CASE SUMMARY SHEET

CASE NUMBER: V26-07-23
DATE RECEIVED: June 24, 2026
DATE OF MEETING: July 14, 2026 and July 28, 2026

REQUEST: V26-07-23 – Joshua S. Brandner, requests a variance to CLURO Section 5.2.3.2. Drainage Overlay District and Fill Sub-Area A, Old Town of Mandeville, Square 10 Lot 2A, B-3 Old Mandeville Business District, 214 Girod

CASE SUMMARY: Allow additional fill at the rear of the property

AS-BUILT DRAINAGE OF
A PORTION OF GROUND SITUATED IN SQUARE 10
TOWN OF MANDEVILLE * CITY OF MANDEVILLE
ST. TAMMANY PARISH, LOUISIANA

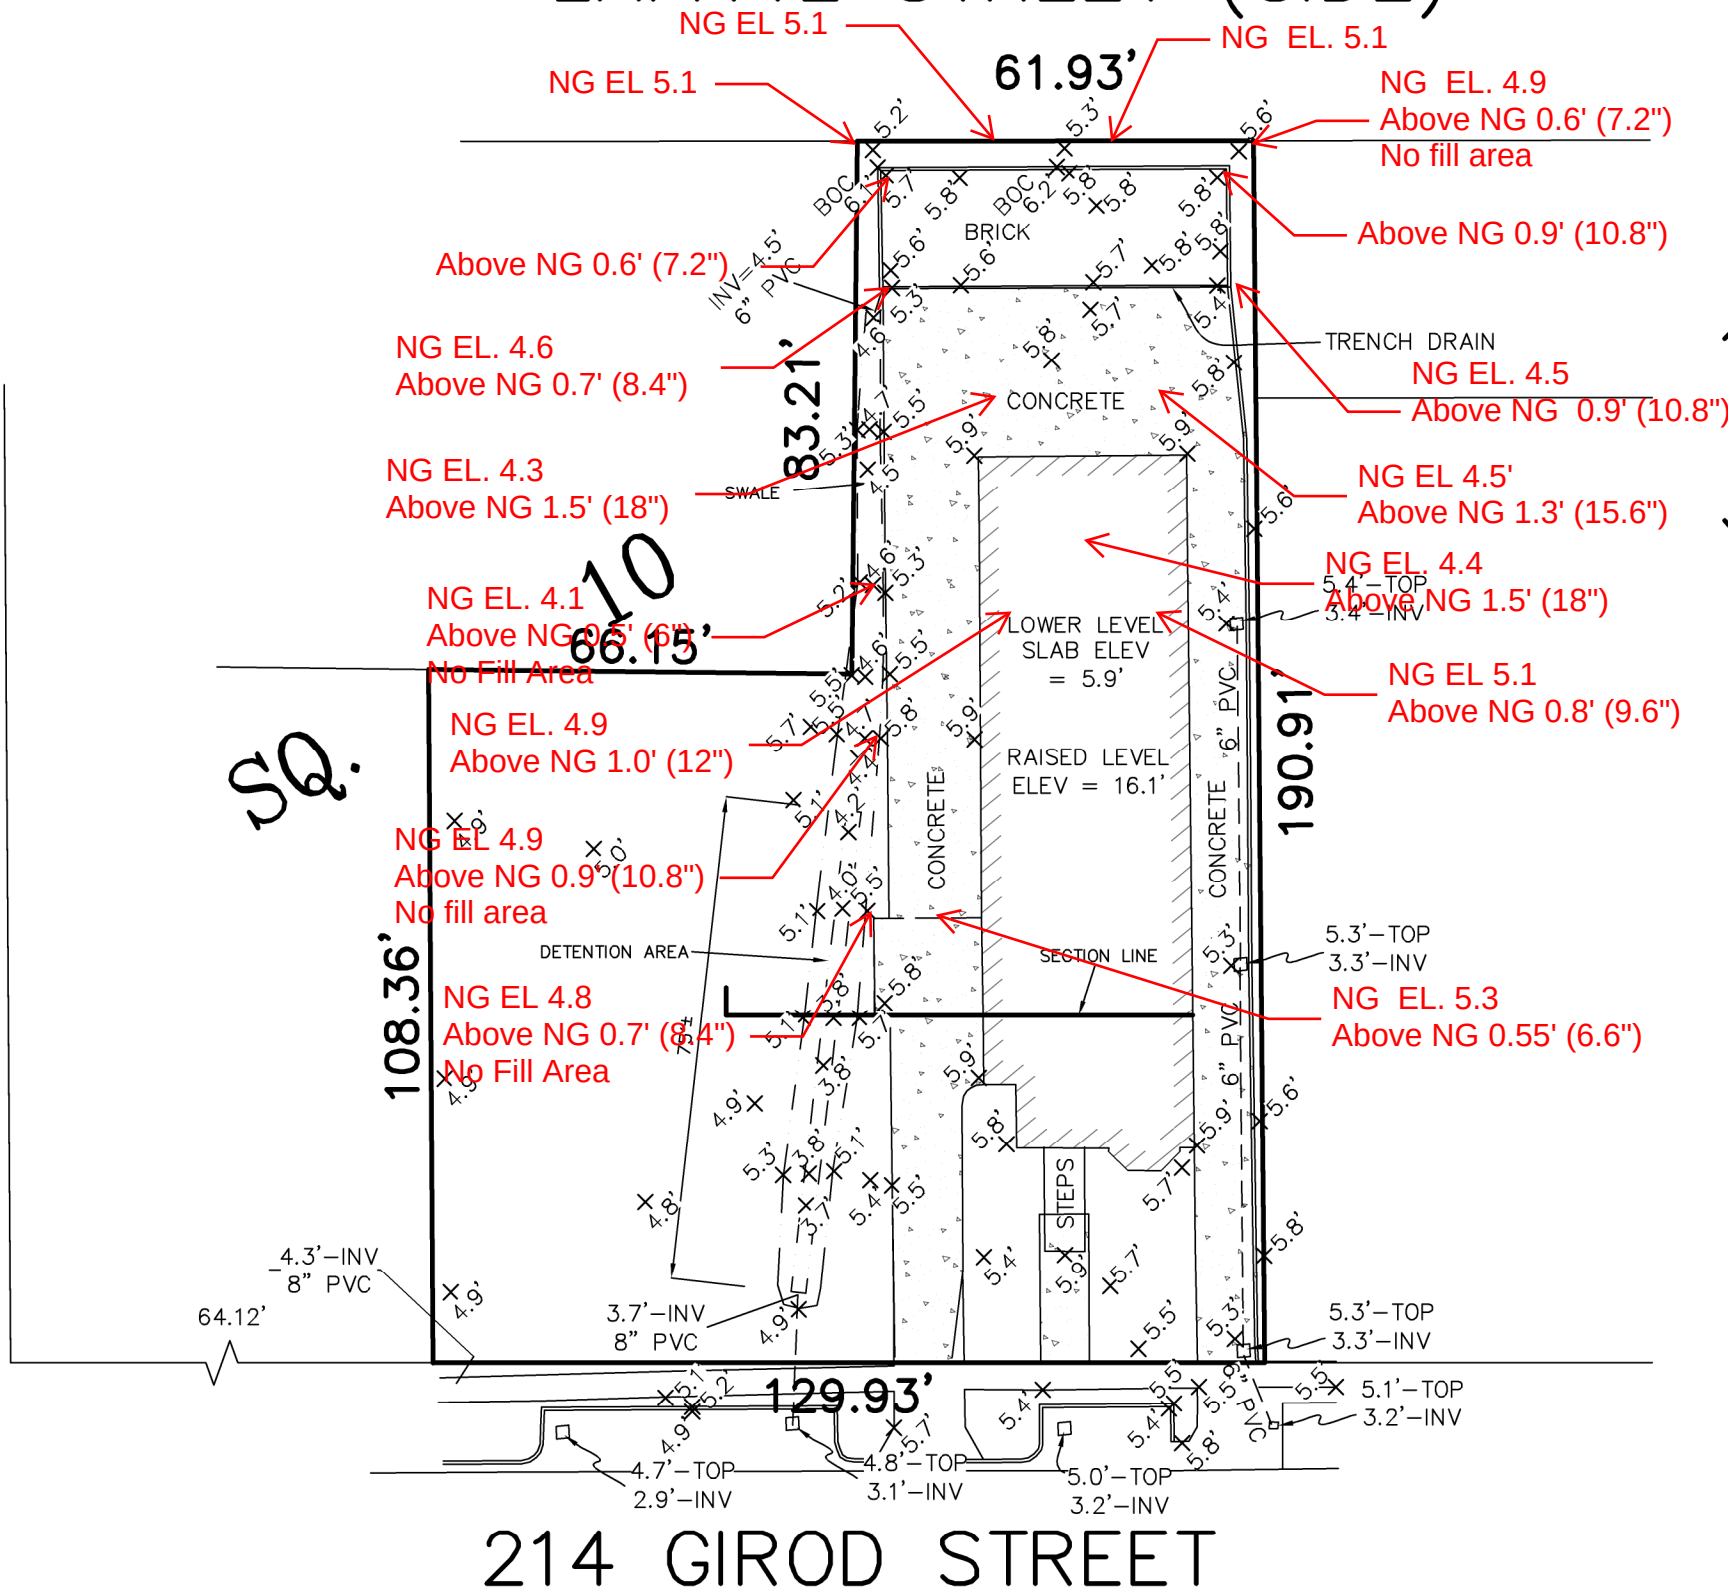
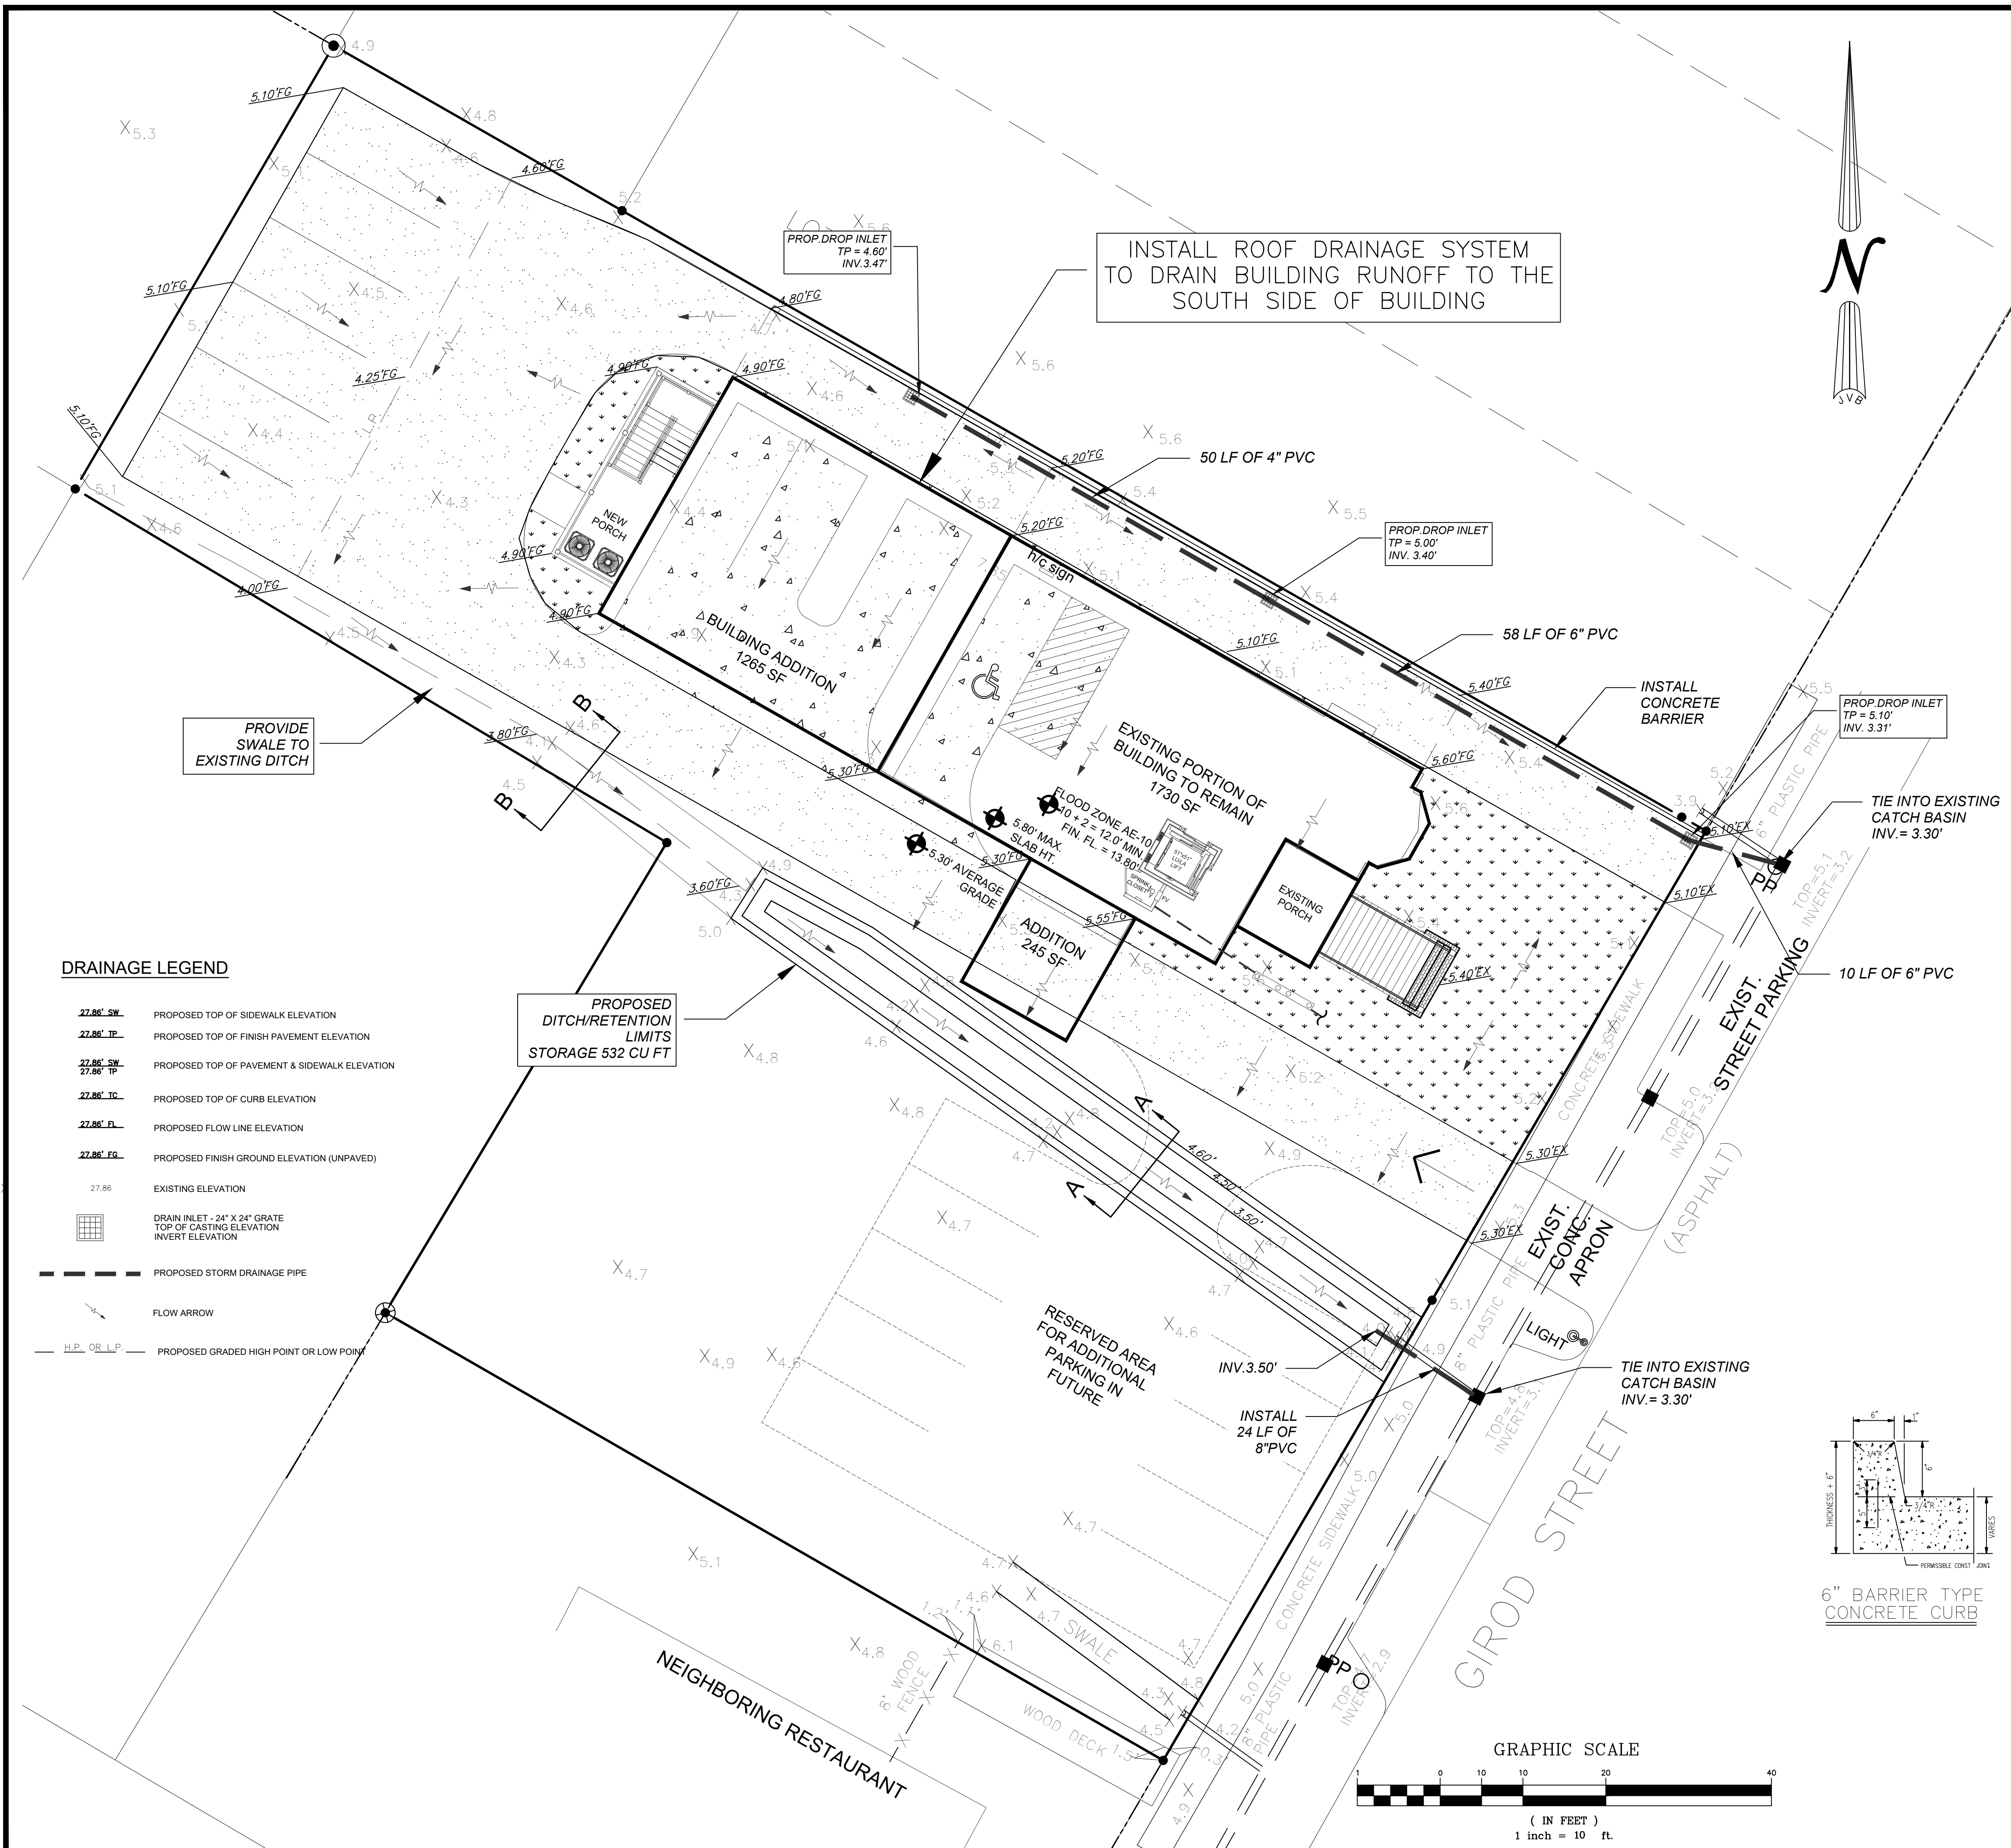
The City Engineer reviewed the submitted documents and had the following comments: *“This project is in both the DO Overlay and Fill area A. It appears they used the grading/drainage plan in the original plan set, that was not approved, was used to set the elevation of the slab under the structure. The first approved drainage/grading plan was prepared by JV Burkes and dated 1/30/2024. See attached. The permittee then requested to change the gravel driveways to be changed to concrete driveways and the gravel parking to permeable pavers, the approved plan was prepared by Kyle & Associates and dated 10/29/2025. Due to not using the plans to set the elevation has resulted in fill up to 18” deep in the rear of the structure”.*

The City Engineer also prepared a figure using the drainage as-built, and noted both the natural grade (NG) of the site prior to construction and the fill above the natural grade in both feet and inches (shown in the parenthesis).

Attached is a figure that I made using the Drainage as-built, I noted the natural grade (NG) of the site prior to construction and the fill above the NG in both feet and (inches). I thought was the easiest way to show.

It appears they used the grading/drainage plan in the original plan set, that was not approved, was used to set the elevation of the slab under the structure. The first approved drainage/grading plan was prepared by JV Burkes and dated 1/30/2024. See attached. The permittee then requested to change the gravel driveways to be changed to concrete driveways and the gravel parking to permeable pavers, the approved plan was prepared by Kyle & Associates and dated 10/29/2025. Due to not using the plans to set the elevation has resulted in fill up to 18" deep in the rear of the structure.

DRAINAGE AND GRADING PLAN

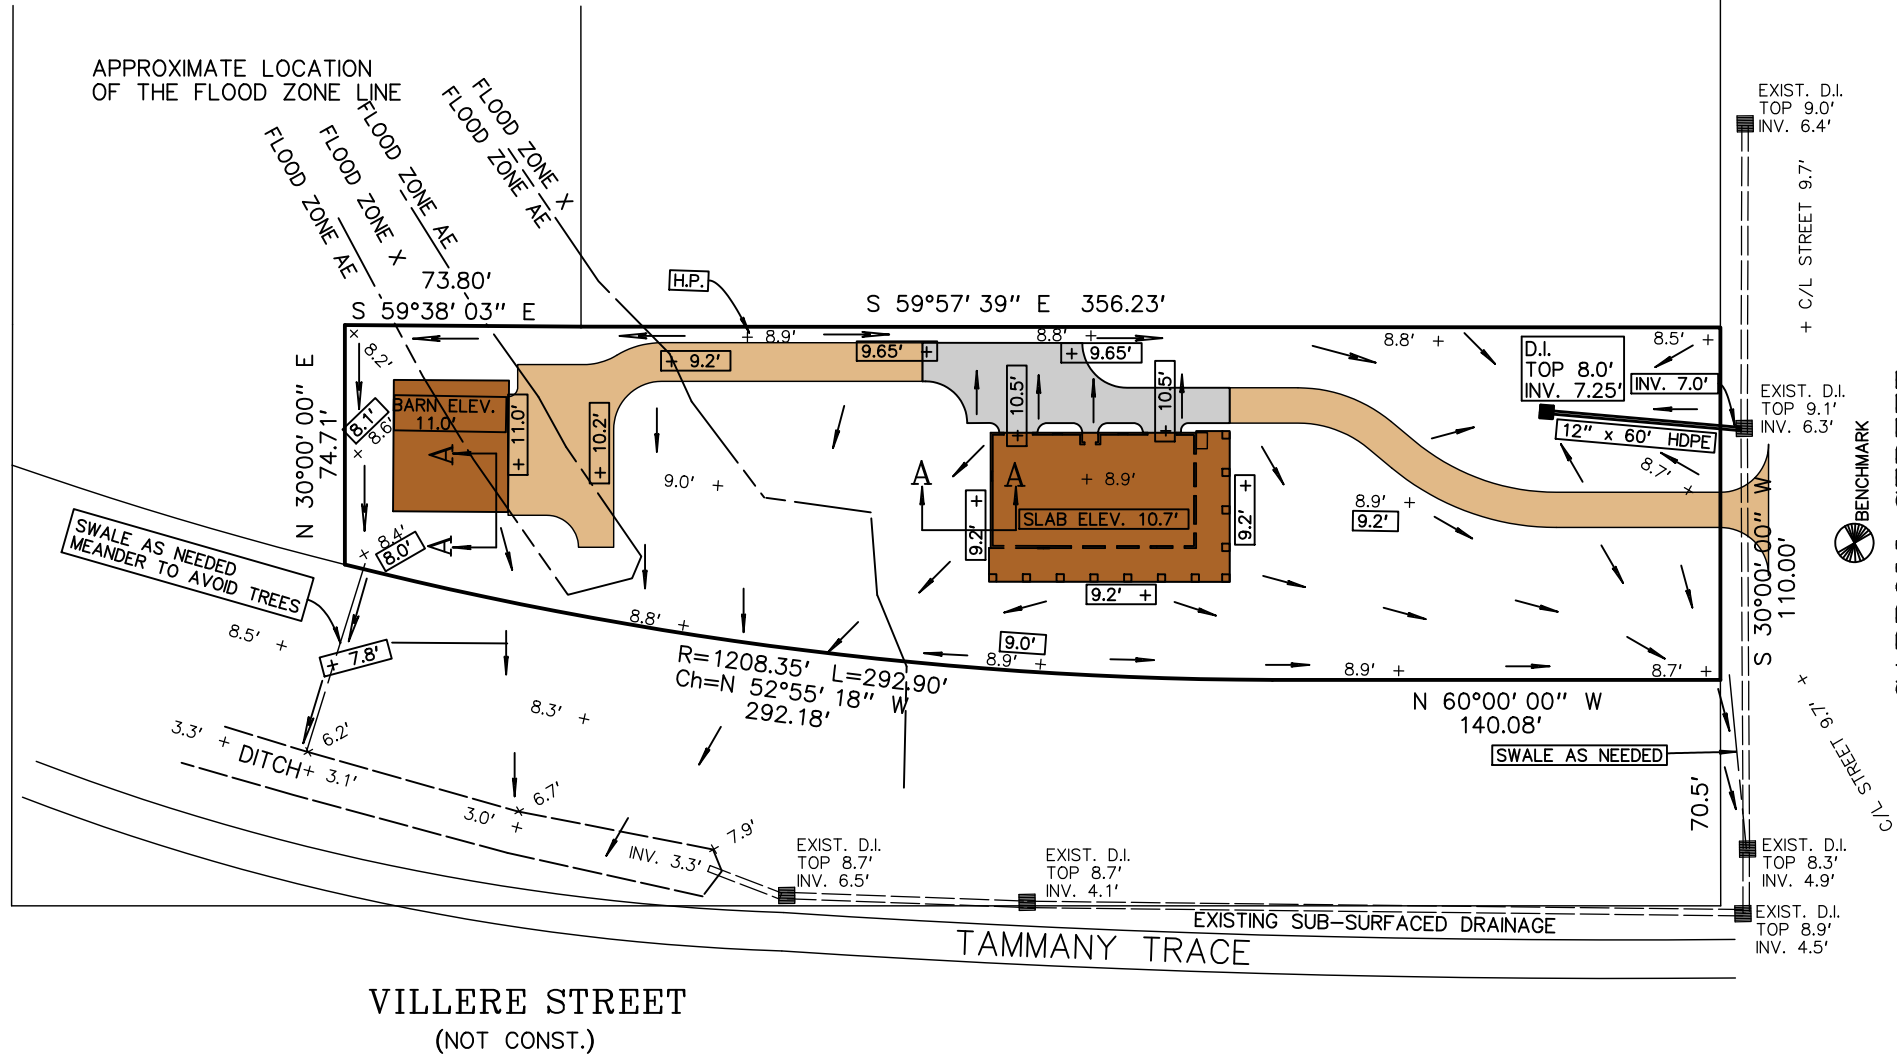
“Public Works received the revised Drainage Plan produced by Kelly Mchugh for Fill height variance at 724 Carroll St. Public Works comments remain unchanged for the request to elevate the top of slab of the proposed garage. The neighbor on Coffee St had concern about the added fill height would cause increased flooding of their garage do to the displacement of volume around Coffee St and the Trace. I have attached the drainage “as built” for 721 Coffee which shows the FFE of the detached garage being 9.20’ which is 1.80’ lower than the proposed structure. Also available in the “as built” are grade shots around the property. The applicant has moved the building within the setbacks. Increasing the setback on the northern property line will allow a greater volume of stormwater to flow around the structure during heavy rain events, but the benefit would be minimal. Kelly McHugh adjusted the slope of the concrete pad in front of the building to decrease the amount of elevation needed to approach the garage openings. The proposed parking/ approach slab would need to be included in the variance request because the elevation would be 0.70’ above the allowable height for a driveway”.

Public Works comments remain unchanged for the request to elevate the top of slab of the proposed garage. The neighbor on Coffee St had concern about the added fill height would cause increased flooding of their garage do to the displacement of volume around Coffee St and the Trace. I have attached the drainage “as built” for 721 Coffee which shows the FFE of the detached garage being 9.20’ which is 1.80’ lower than the proposed structure. Also available in the “as built” are grade shots around the property. The applicant has moved the building within the setbacks. Increasing the setback on the northern property line will allow a greater volume of stormwater to flow around the structure during heavy rain events, but the benefit would be minimal. Kelly Mchugh adjusted the slope of the concrete pad in front of the building to decrease the amount of elevation needed to approach the garage openings. The proposed parking/ approach slab would need to be included in the variance request because the elevation would be 0.70’ above the allowable height for a driveway.
